**Requirements by Transit New Zealand for  
Designation of State Highway 2  
(Tauranga Eastern Arterial)**  
**and**  
**Tauranga District Council  
for Bell Road Interchange**

| <b>Addendum to Requirements by Transit New Zealand for Designation of State Highway 2<br/>(Tauranga Eastern Arterial) and Tauranga District Council for Bell Road Interchange</b> |           |
| <b>Section A – Assessment of Effects of Proposed New Alignment from Bell Road<br/>Interchange to Kaituna Road.....</b>  | <b>1</b>  |
| <b>Section B – Design Adjustment at Paengaroa Interchange.....</b>  | <b>12</b> |

Figure 2

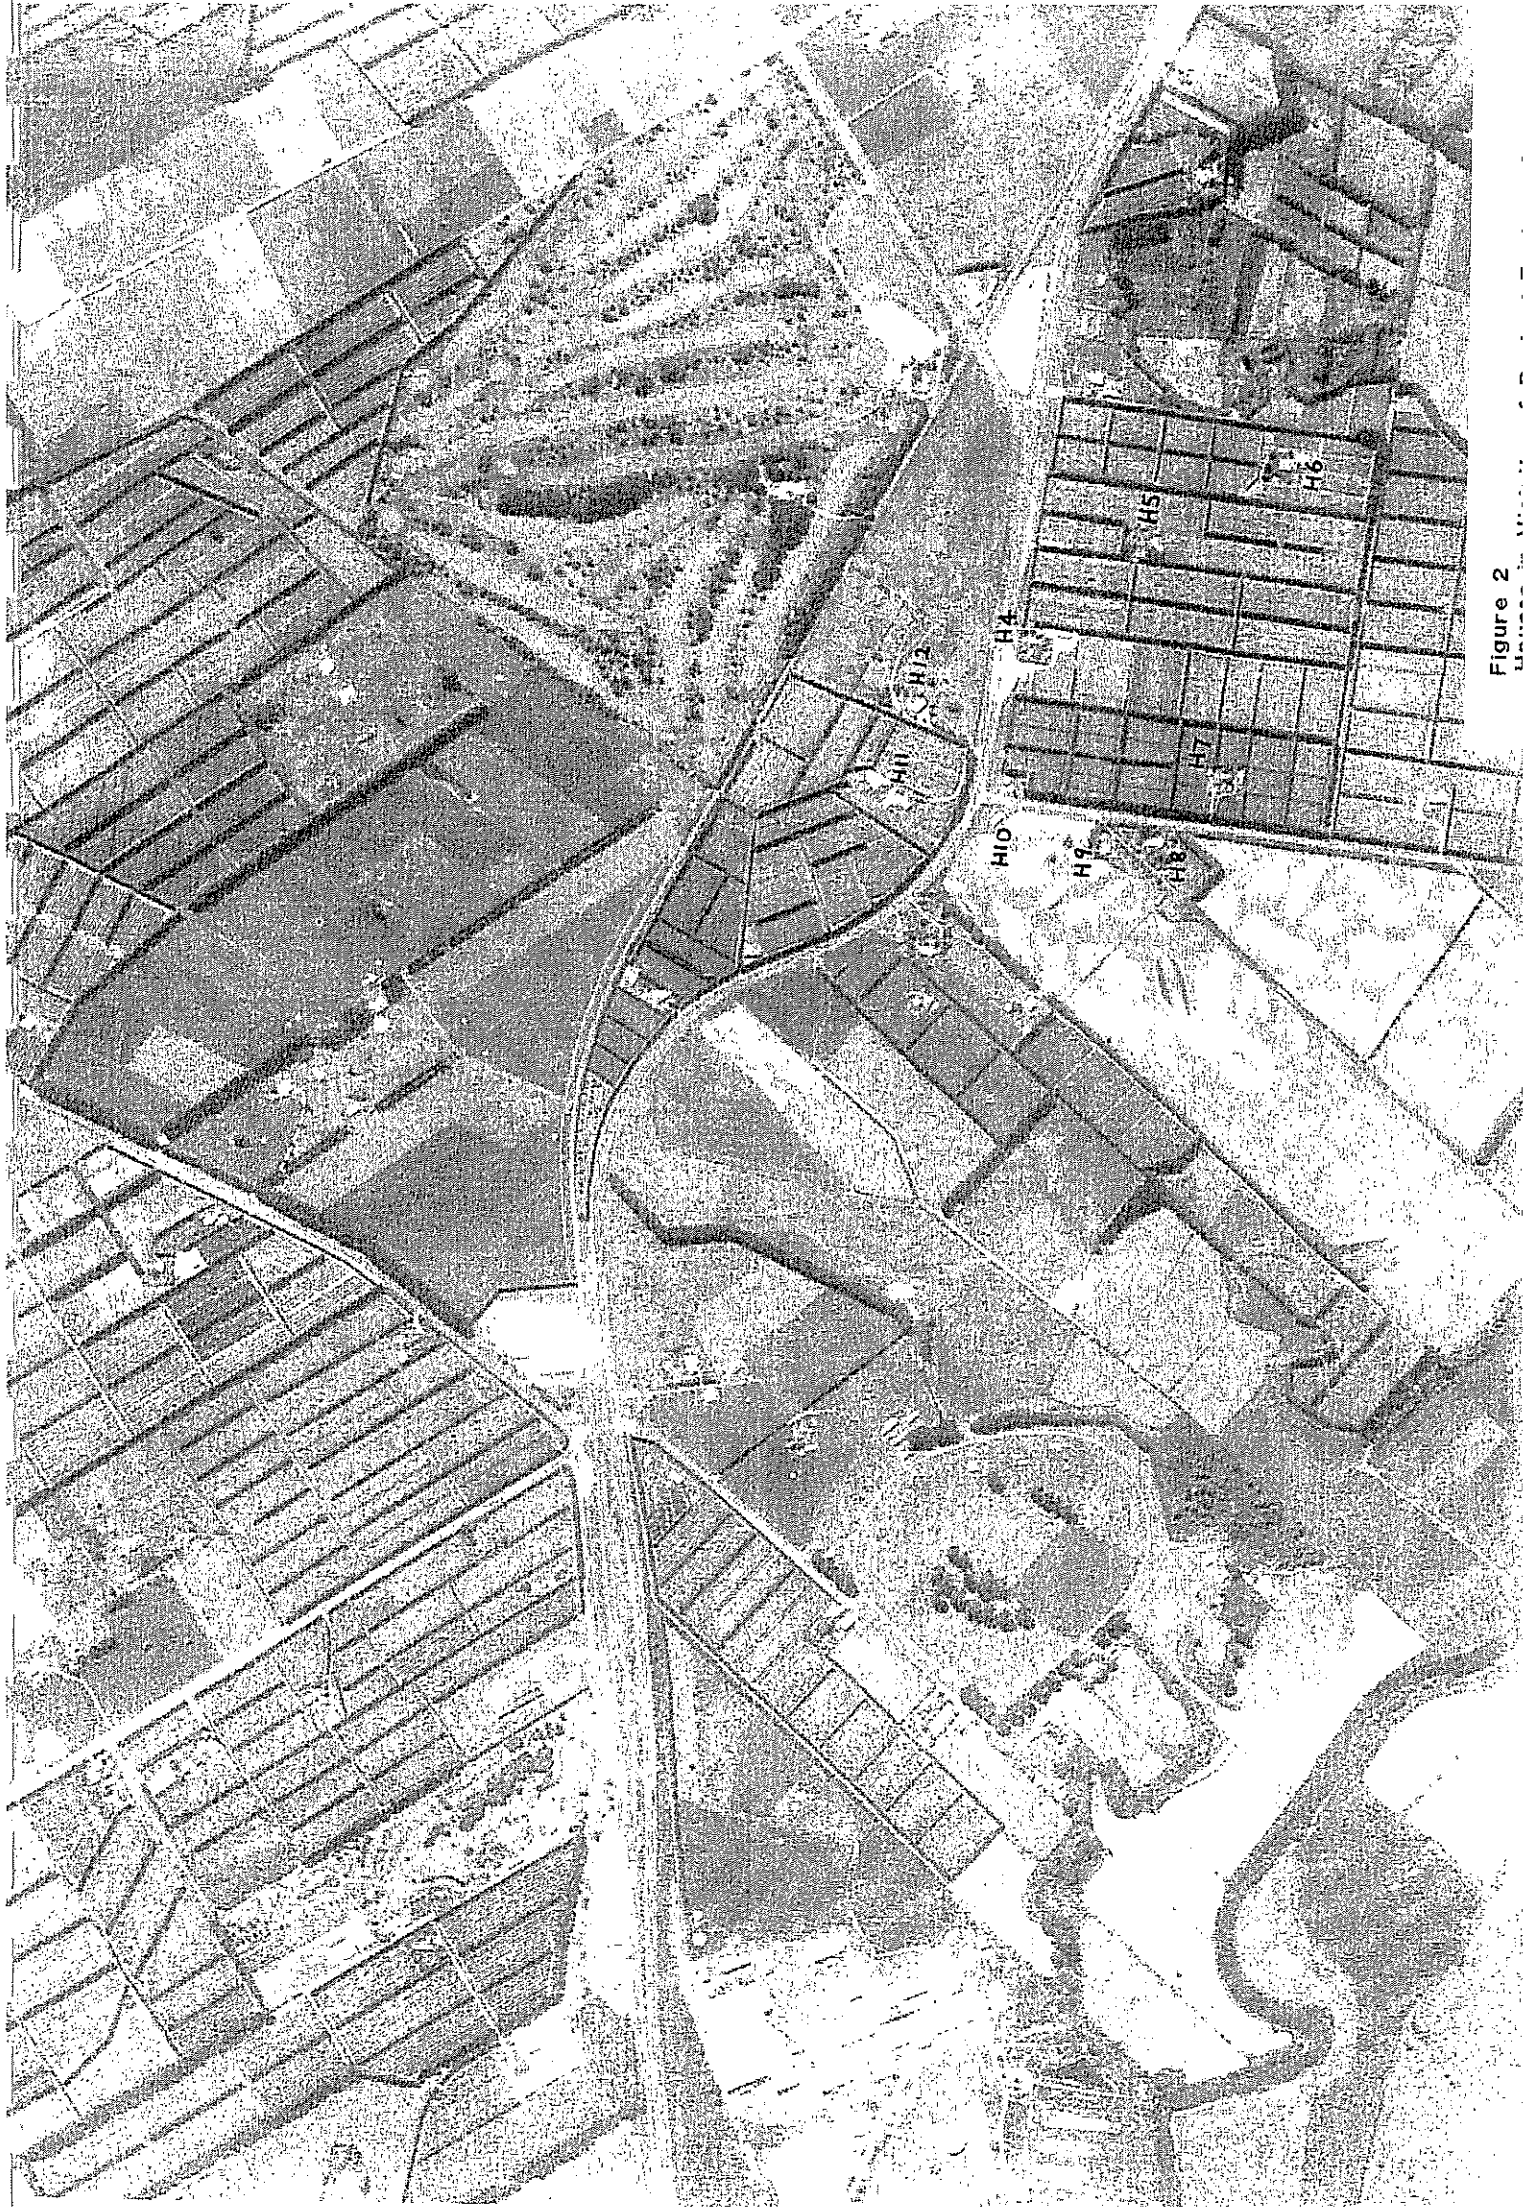
In comparison with the previous alignment the major change has been to eliminate the loop of road which crosses over the TEA from Whakatane entering into properties on the western side of the existing SH2. The effect of flattening out the alignment of this section of road is to move that source of noise (about 7,000 vehicles/day) further away from houses on the western side of the existing SH2 (H4-H20 see attached Figure 2), thus reducing their potential noise exposure by a small, but in some cases, a noticeable amount.

Our conclusion therefore is that this amended layout of the junction is slightly preferable on noise grounds to the original layout, but both layouts are capable of meeting Transit's design guidelines for noise.

**FIGURE 5.11  
REV. A**

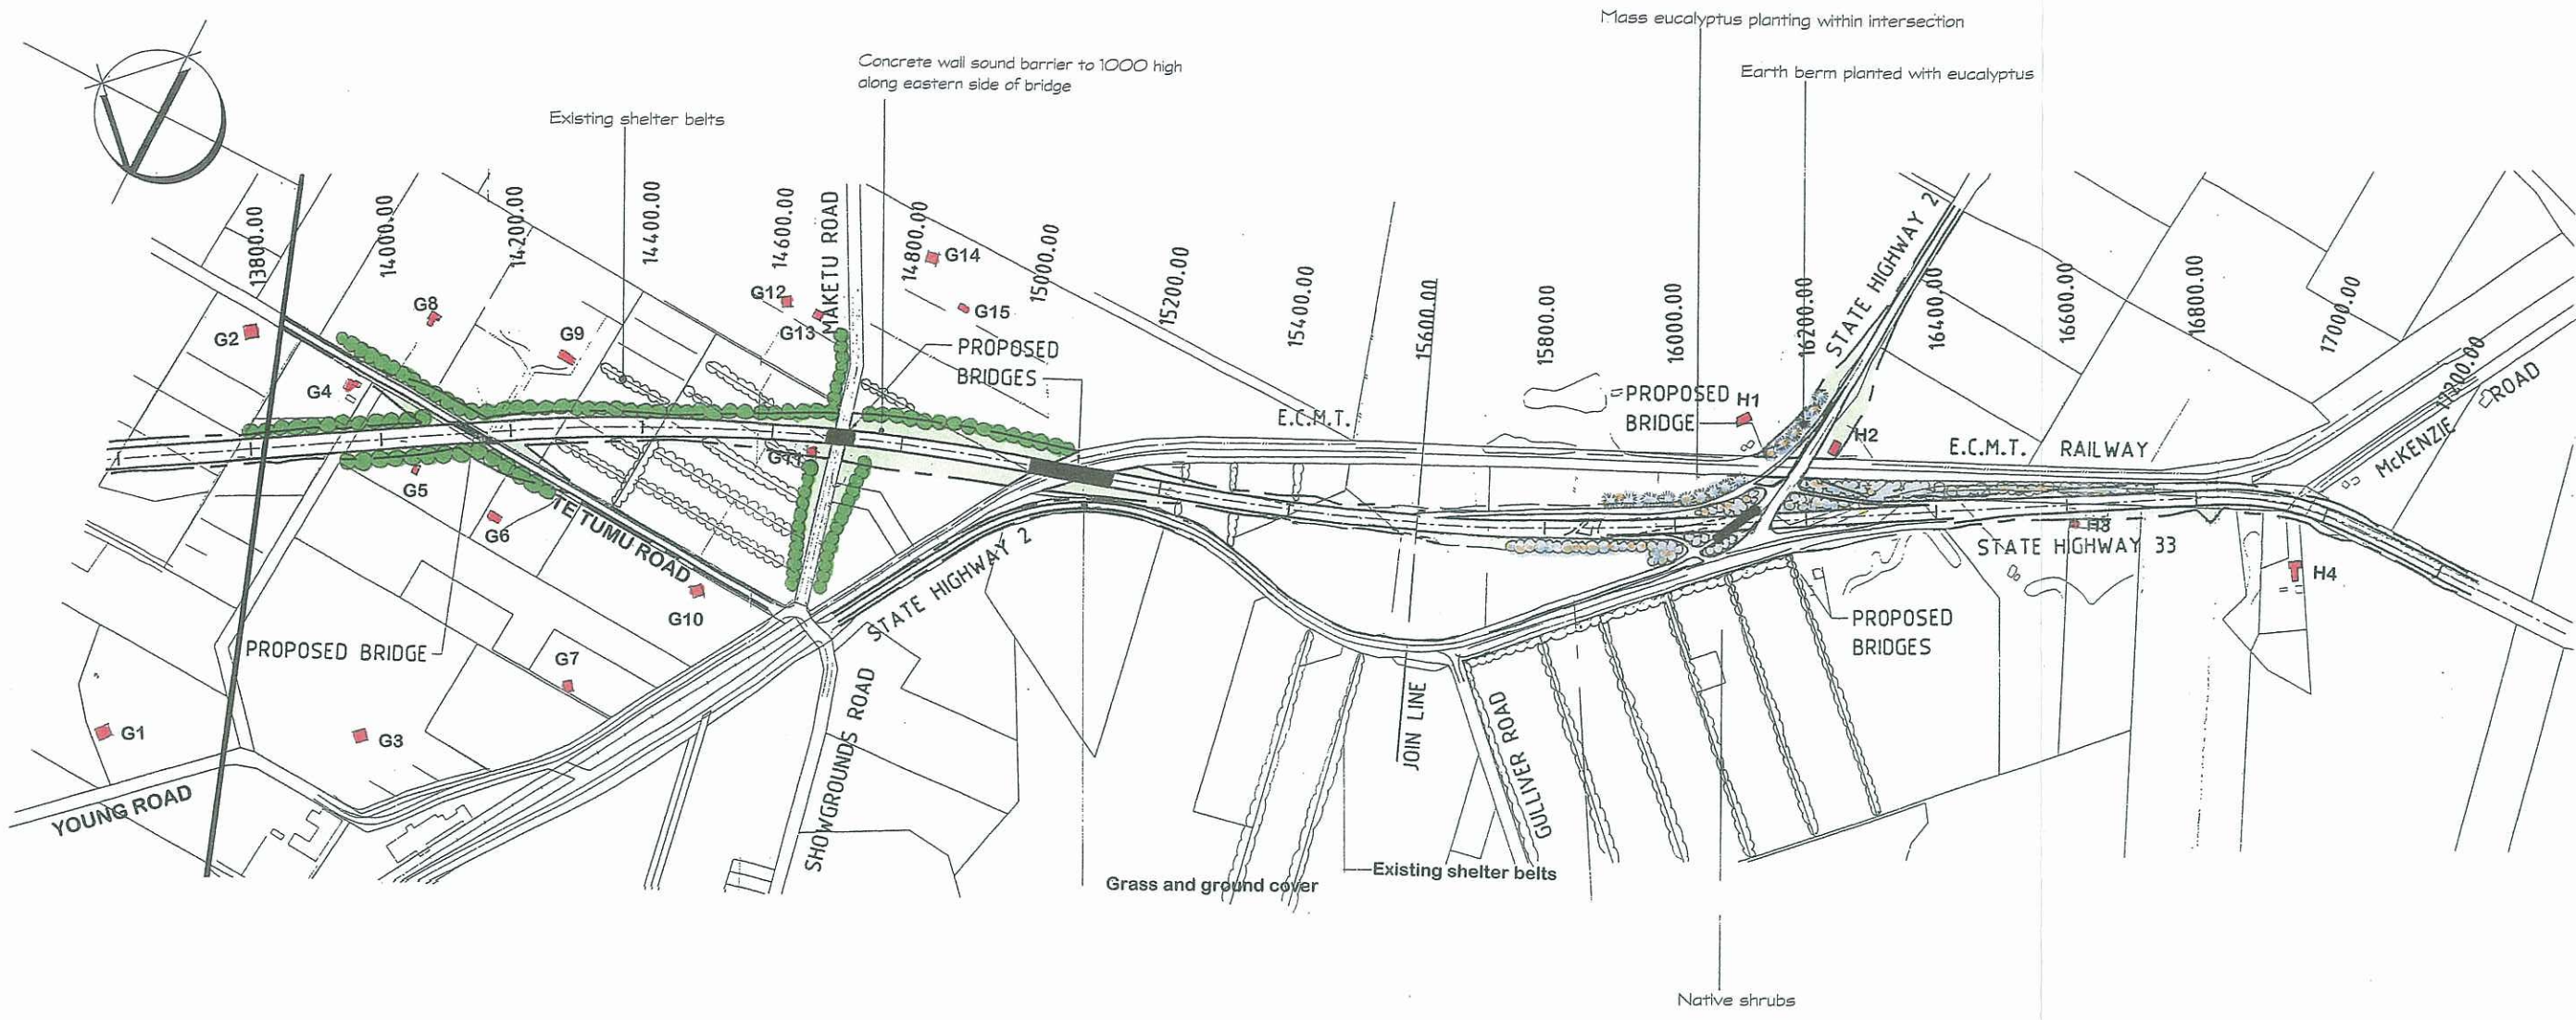
Three houses F6, G12 and G13 will be close to the new alignment and G5 and G 11 will be removed by the arterial.

The potential for both landscape and noise mitigation is very good. Almost the whole alignment through this area will be screened by shelter belts combined with a sound barrier fence in places close to houses. The aim will be to tie new shelter belts into existing ones in order to complete the screening. Planting will be carried out on the embankments of the two bridges to ensure that as much as possible of the new road is screened. Where fencing is used, new shelter belts will be backed by a 2.5 metre high fence, with a further shelter belt planting inside the fence, thereby ensuring a reasonable view both inside and outside the road corridor.

Refer to LA4 Plans - Concept Landscape and Mitigation. Plan 4 and 5. (Figures 5.10 and 5.11)

Espin  
Suggestion

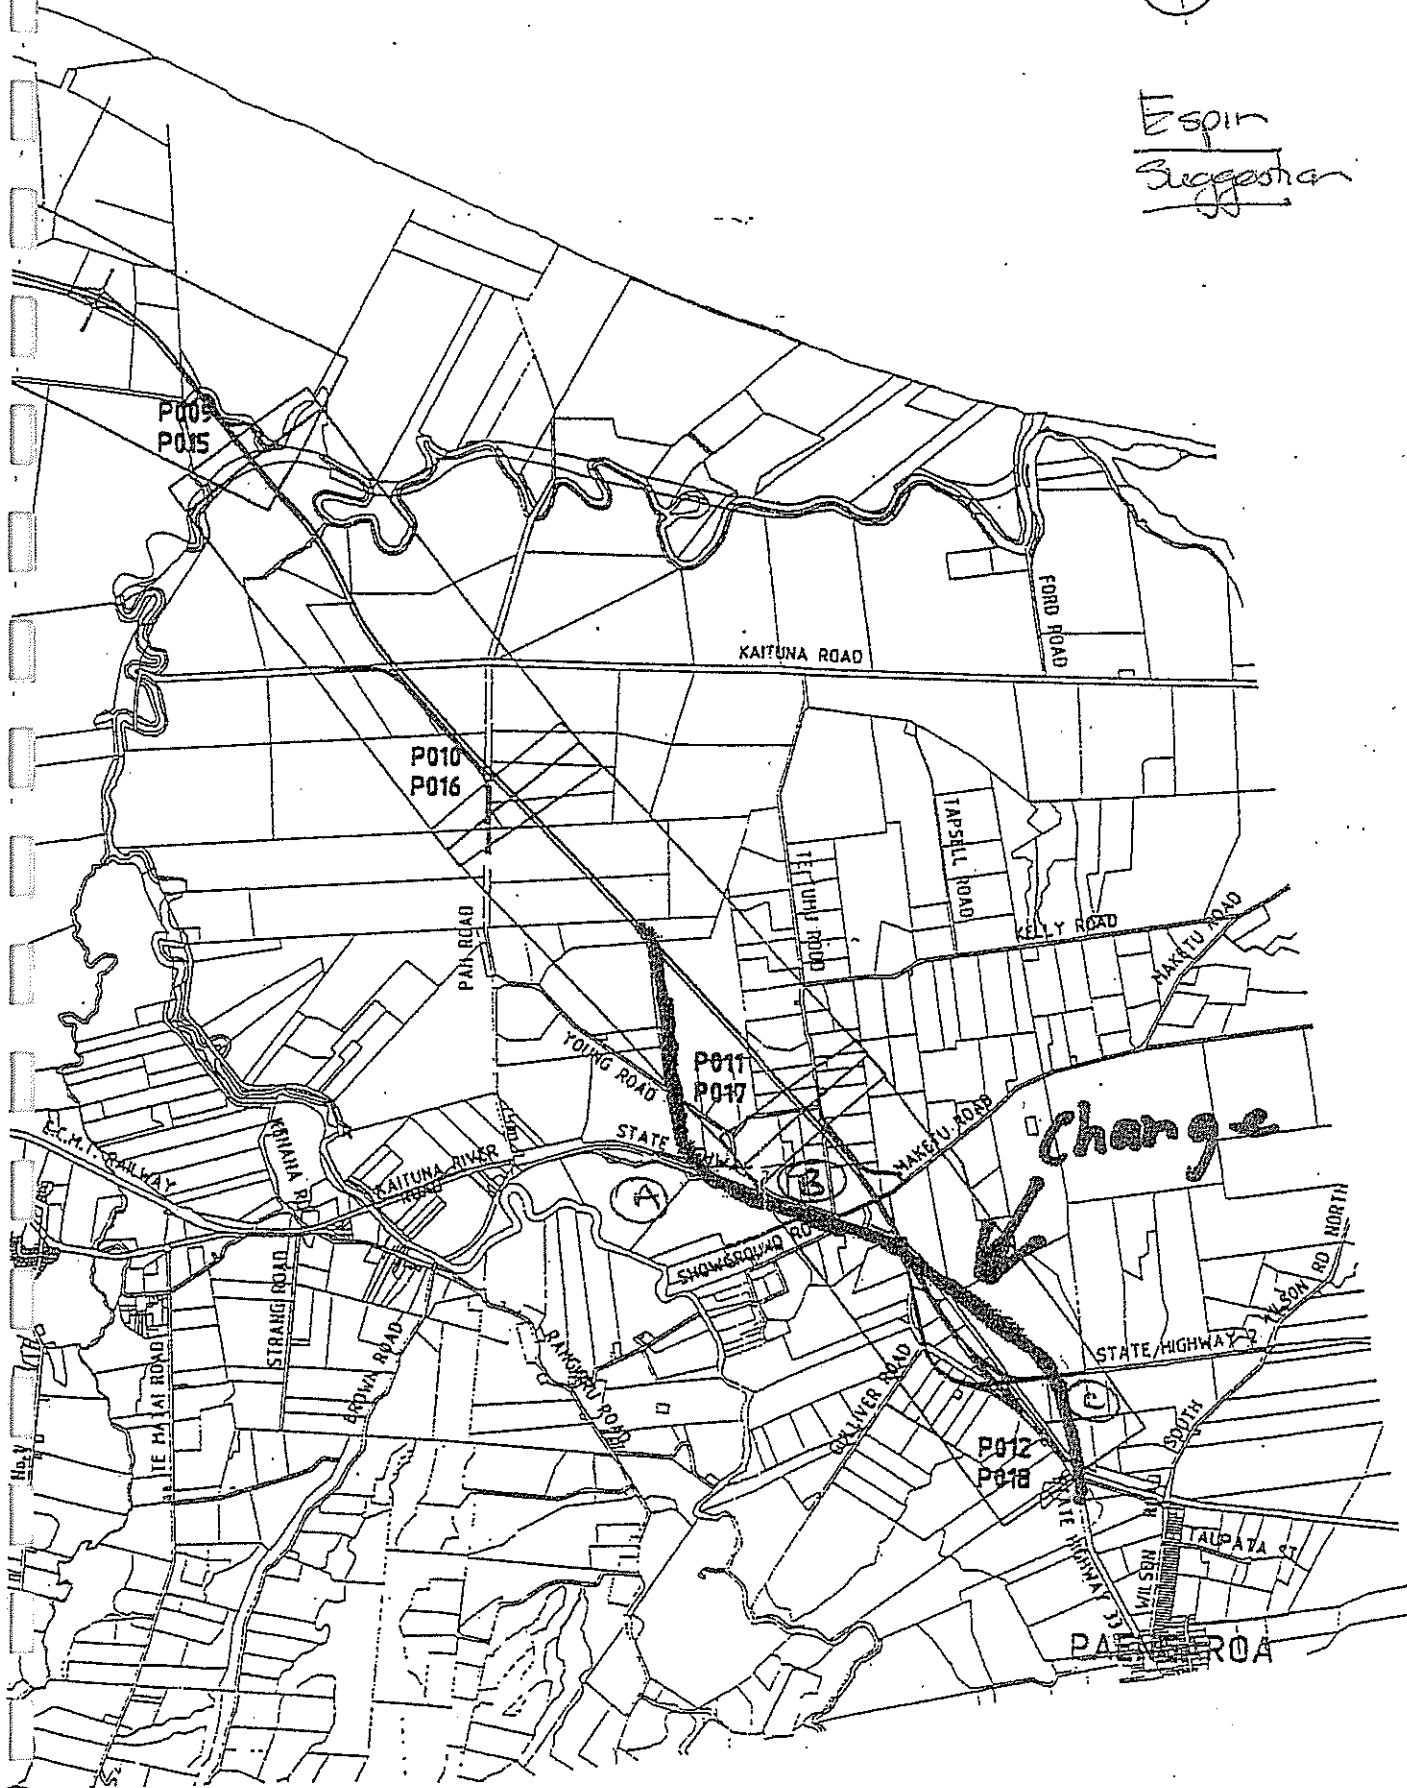
1. It is difficult, if not impractical, to get a junction with the existing State highway, clear of the existing railway line with access to Te Puke in the position (A) shown on the marked up plan.

2. The alternative alignment would have an adverse effect on the existing kiwifruit packing houses, Kiwifruit Country and also the golf course.
3. It is extremely difficult, if not impractical, to also provide for an intersection which contains the junction of Young Road, Te Tumu Road and Maketu Road along with the railway line and the existing State highway and still provide for the Tauranga Eastern Arterial on the alternative alignment as shown marked (B).
